Technical Service Bulletin

No.A412-001v2

Subject/Concern:	Defrost Vents Rattling or Displaced
-------------------------	-------------------------------------

Models:		
X-TYPE		VIN-range: C00294-E96114

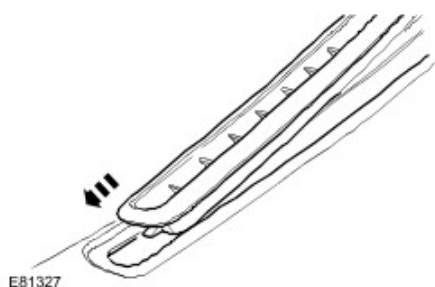
If the outer end of defrost vent (nearest the A-pillar) is adrift:

- 1 . Install a new demister vent plug.

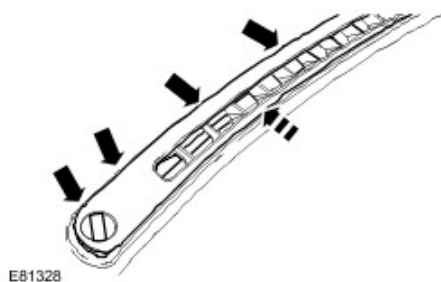
- 3 . Install the inner end of the new defrost vent with the new locating feature first.

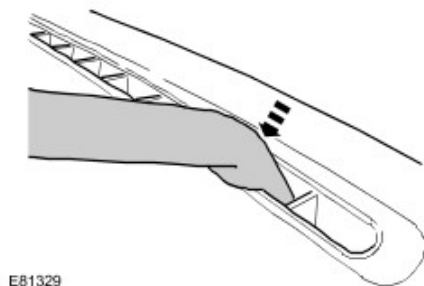
- 4 . Locate the front edge of the defrost vent under instrument panel material, making sure the small triangular projections along the front edge of the defrost vent are located.

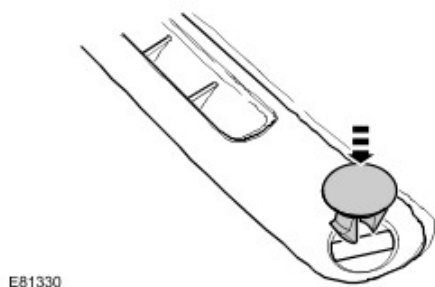
- 5 . A suitable tool should be used to clip the rear edge of the defrost vent down, working along the vent towards the A-pillar.

- 6 . Install a new defrost vent plug.
